TECHNICAL SERVICE BULLETIN

NO. 182-001**SUBJECT:** GUIDE BAR INSERT KIT #A-96612**AFFECTS:** 360 CHAIN SAW

INSTALLATION OF GUIDE BAR INSERT FOR 360 CHAIN SAWS

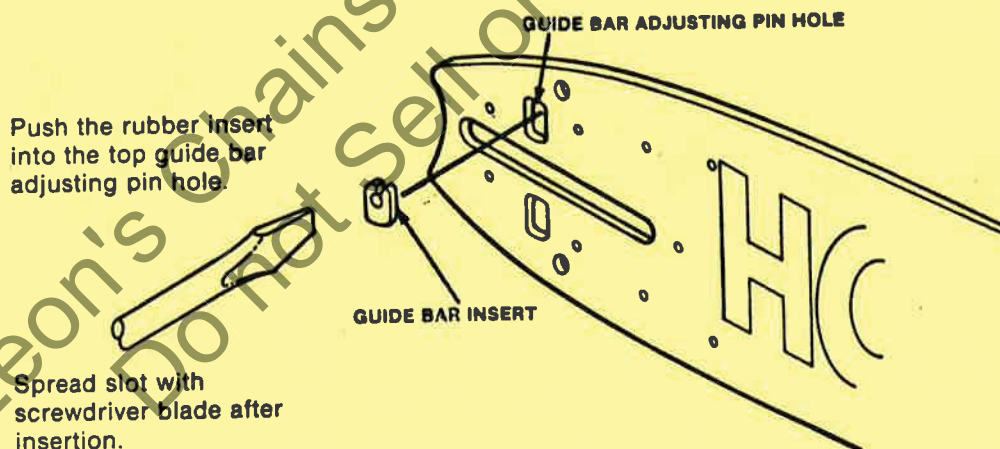
We have had reports from the field that when guide bars longer than 16 inches are used on 360's a minimal amount of oil is getting to the chain. In order to improve the oil flow to the chain a rubber insert for the chain adjusting pin hole of the guide bar has been designed. (See illustration). This insert will route the oil from the oil slot in the guide bar pad directly to the groove of the guide bar.

This insert will be in the new 360 owners kit. If extra inserts are needed order part number A-96612. This kit will contain 5 inserts and 1 instruction sheet.

INCORRECTCORRECT

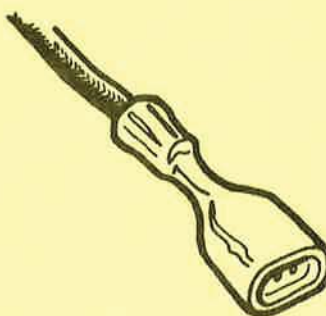
2. Some switch leads, part number A-96378 may have the wrong style connector. Compare your stock to the picture below. The correct connector is colored red and the incorrect is pink. DO NOT use the pink ones for service. They will break after a short time.

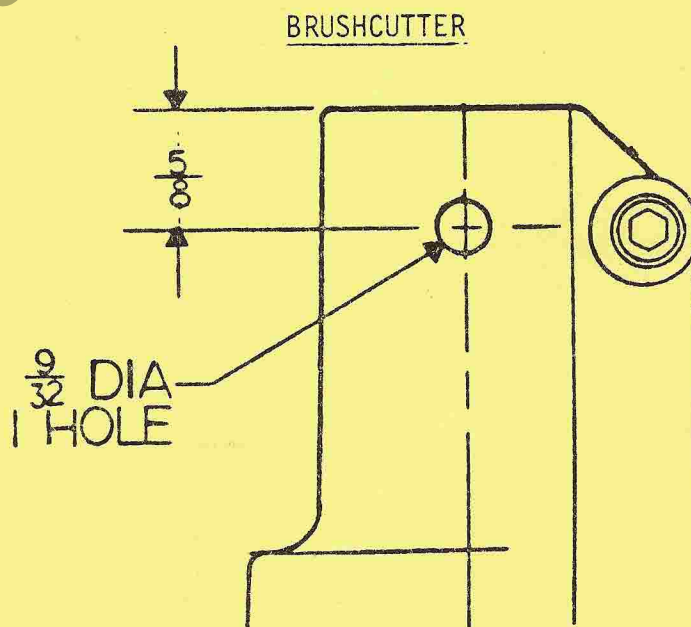
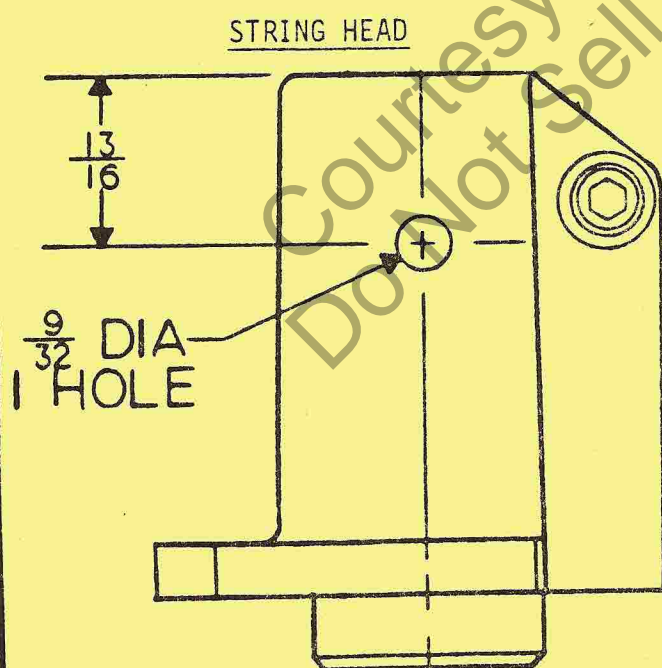
Before the 1982 season all ST-200's were built with the locating hole for the brushcutter or string head in front of the tube. Some tubes of this type broke just above the brushcutter or string head. In order to correct this in the 1982 season, the locating hole was moved from the front to the side and raised closer to the top of the brushcutter or string head housing.

All units built in 1982 have the hole on the side of the tube. A problem arises when a new 1982 ST-200 (hole in side of tube) is matched with an old brushcutter (hole in front of housing). In order to solve this problem use the templates below to drill a new locating hole in the side. Use a $\frac{9}{32}$ " (.2812) drill bit.

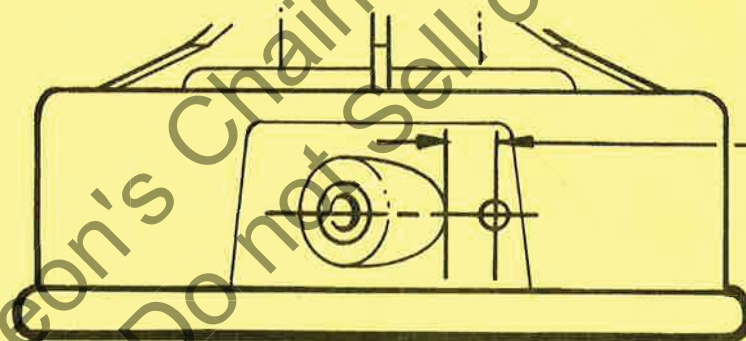
1. As stated in a previous bulletin, the Weldnot tubes are now retained to the stringhead with a cotter pin. A hole is drilled through the stringhead near the string eyelet. The pin is then inserted into the hole and spread apart. This keeps the Weldnot tube from "pounding" the eyelet.

Old stringheads can be updated to accept the new Weldnot tubes. A hole must be drilled near the eyelet for the cotter pin. Refer to the drawing below for the location of this hole. The hole diameter is $\frac{1}{8}$ " (.125). The distance from the eyelet to the center of the hole is $\frac{1}{4}$ " to $\frac{3}{8}$ ".

OLD - ANGLES FORWARD

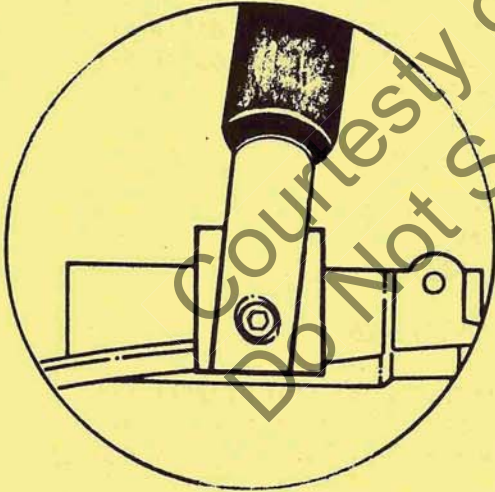
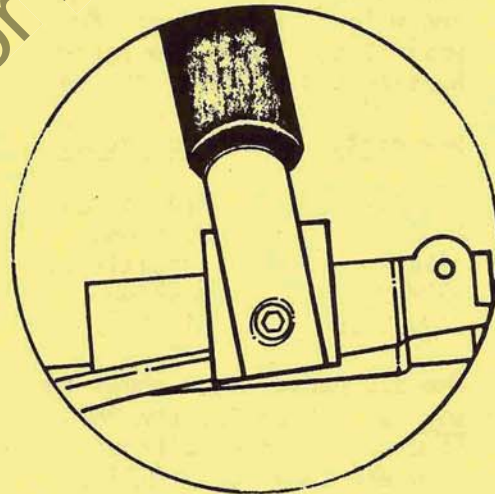
2. The 330 parts lists shows two bumper spikes. Both spikes will fit any 330. However, the 95838 is designed for the chain brake model. It can be mounted without removing the brake cover and is 1/2" shorter in width than the A12272-C.

Currently kit A12272-C contains a spike and two 10-24 x 3/8 screws (88048). In order to use this spike on later 330 models you must also obtain one 10-24 x 3/4 screw (88051) to substitute for one of the 88048 screws. Soon kit A12272-C will be superseded by A12272-D and will contain two 88048 screws and one 88051. The "-D" kit will fit both the 330 and 360.

Illustration 1

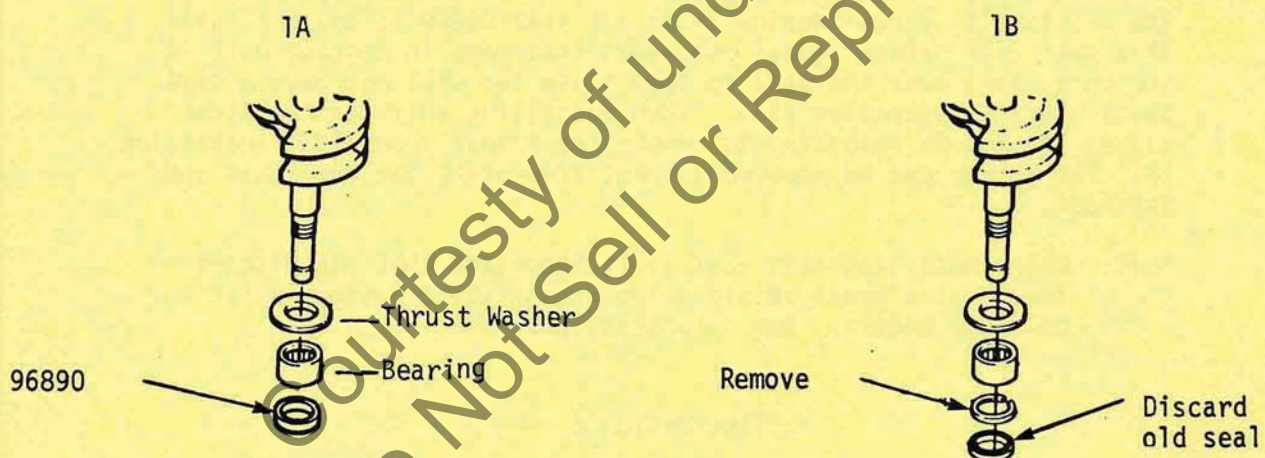
2. To prevent grass from entering the oil seal on the string side of the crankshaft, a new "marine type" oil seal 96890 is now available. This seal will "shear" grass and weeds that come in contact with it. New units that have the seal factory installed will not have a seal spacer (see illustration #1A). When installing this seal on older units, it will be necessary to remove the spacer shown in illustration 1B. The spacer can be removed without separating the crankcase and cylinder.

Drill Through
#43 Drill Bit

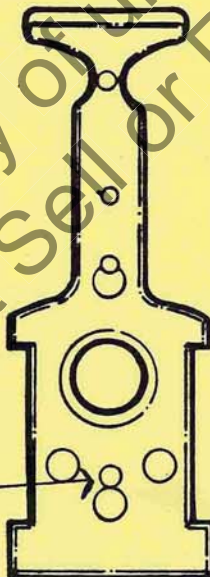
Your customer may complain that the trimmer floods too easily and that he cannot hear the engine "fire" the first time. This can be remedied by drilling a small hole in the choke. See the illustration below for size and location.

The hole will allow more air to enter the carburetor venturi creating less vacuum and therefore drawing less fuel into the engine.

OLD DESIGN

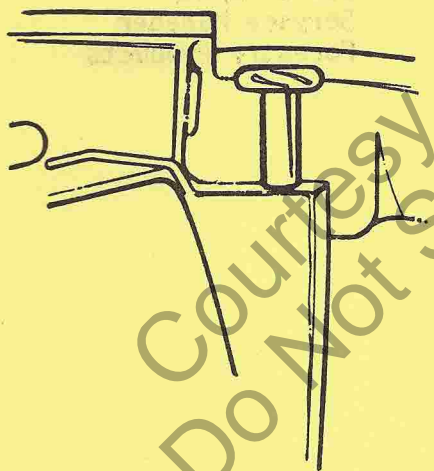
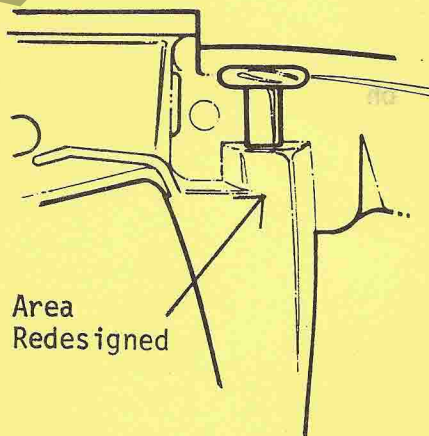
1. The throttle handle has been redesigned to lengthen the bore for the manual oil pump plunger (see illustration). This was done to minimize the "side to side" movement experienced by the plunger when the user depresses the button. The part number did not change. The current number is A93926. This change is effective with the serial number OD2250000 and above.

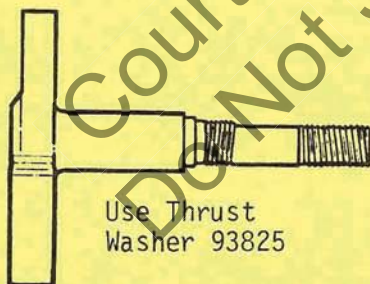
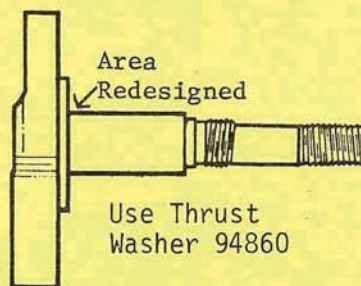
1. To improve unit performance and durability a new piston design A95882-A is available for all 330 chain saws. This new piston incorporates narrow piston rings number 96510. When "thick ring" pistons A95882 are no longer available the part number will be superseded by A95882-A. Note that the "thick" piston rings 93823 are still available.
2. Also, the crankshaft was redesigned in the thrust washer area to increase crankshaft durability. This change required a redesign of the thrust washers. The new washers are part number 94860. Old thrust washers 93825 are still available for servicing crankshafts made before this change. All new crankshafts A96418-B will include thrust washers. See picture below.

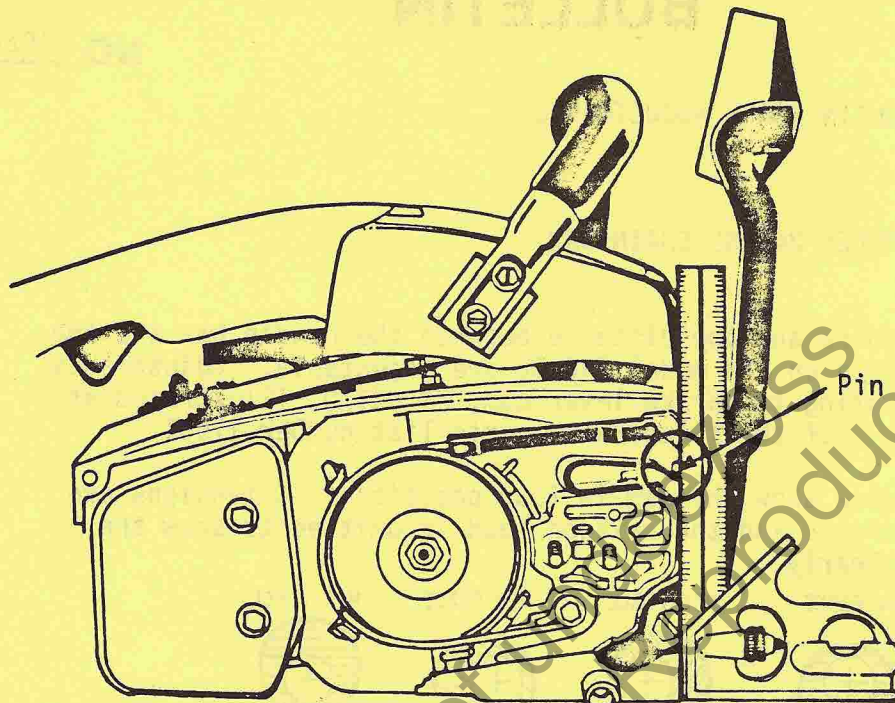
The sketches below show the cam in four positions. Dimensions are somewhat exaggerated and the hexagon head is omitted to show the cam positions clearly.

At MAX FORCE and at MIN FORCE adjustments, the paddle to handle distance is identical and intermediate.

As shown by the two center sketches, intermediate actuating forces may be selected with the paddle moving away from, or toward the handle bar.

To change paddle location, or to change actuating force, study the sketches and rotate the cam accordingly.

Force adjustment range is approximately $1\frac{1}{2}$ pounds (0,7 kg). Distance adjustment range is approximately .22 inch (5,5 mm).

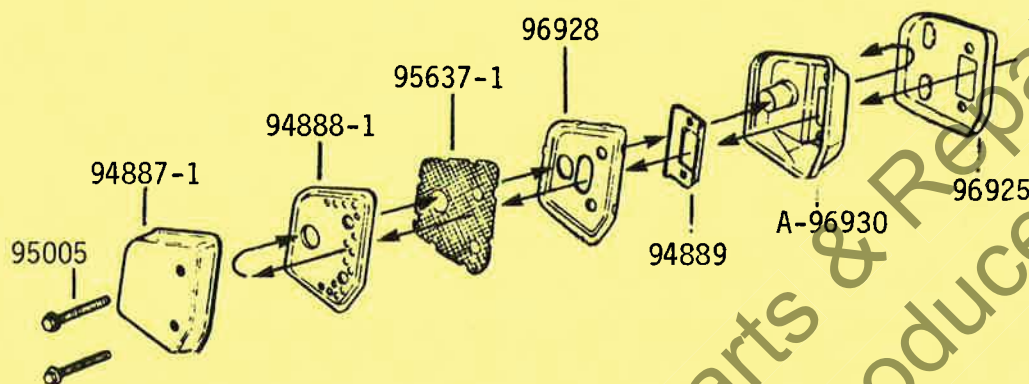
2. A new muffler is used on all 240 chain saws above serial number XD200XXXX. The exhaust is now directed to the rear of the muffler and exits near the cylinder.

NOTE: The muffler cap does not have holes for the exhaust to escape through.

Arrows indicate direction of exhaust flow.

FIGURE "A"

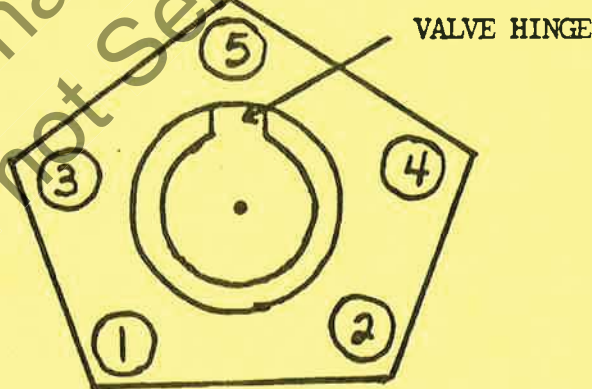
1. Coat both the faces of the pump body and the discharge fitting with a lubricant. Dow Corning number 4 compound, Homelite number 22636-B is used in the factory, and has been found to be the most effective.
2. Snug up the bolts in sequence shown in figure "A" but do not torque at this point.

FIGURE "B"

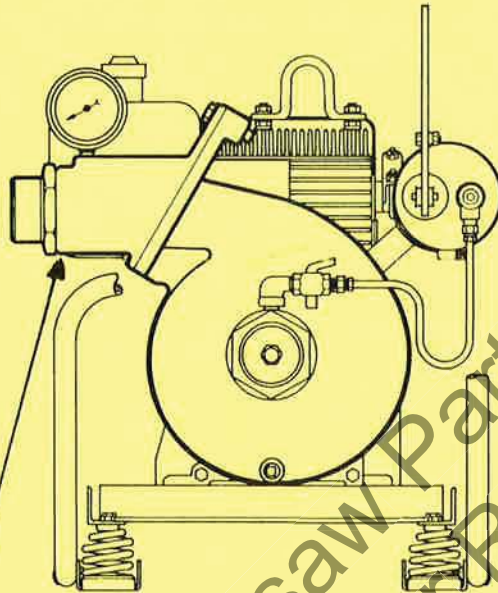
3. Strike the bottom of the valve body several times in an upward direction with a soft mallet, as shown in figure "B". This properly positions the valve on the valve body. Inspect the valve with a flashlight to assure the valve hinge is completely flat against the valve body. This is easily determined by pushing on the hinged area with a screwdriver. If the valve is not flat you will detect movement of the valve.

4. Torque all bolts to 240 inch pounds in the sequence shown in figure "A". Check the rubber valve again as described in step number 3. If valve is not flat, repeat procedure.
5. Test pump by measuring maximum vacuum which should be approximately 22 inches of mercury. If maximum vacuum cannot be obtained and the valve is seated properly then the check valve is not the problem.

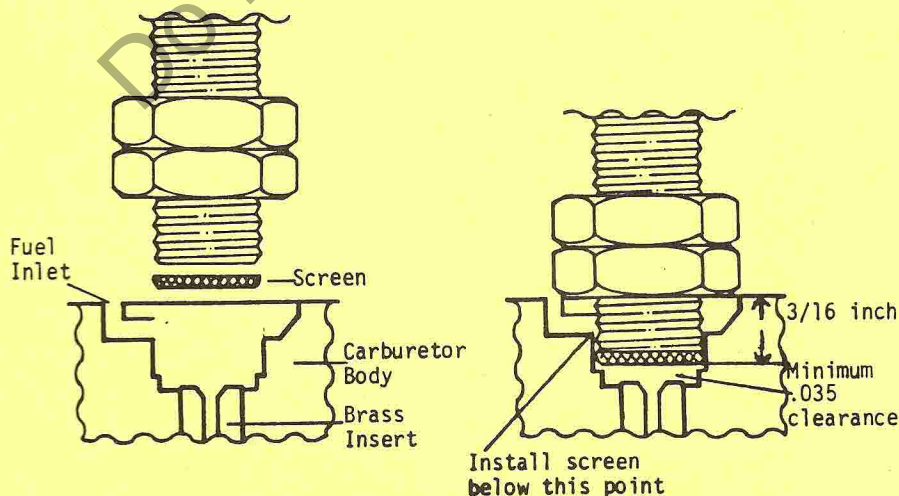
Do not press the screen too deep in the carburetor during installation. a 5/16 - 24 bolt with two nuts is a simple and available tool to install the screen properly.

Use the two nuts to maintain the 3/16 inch depth. This allows the screen to be set in place without blocking the fuel inlet hole, or touching the brass insert pressed into the carburetor body.
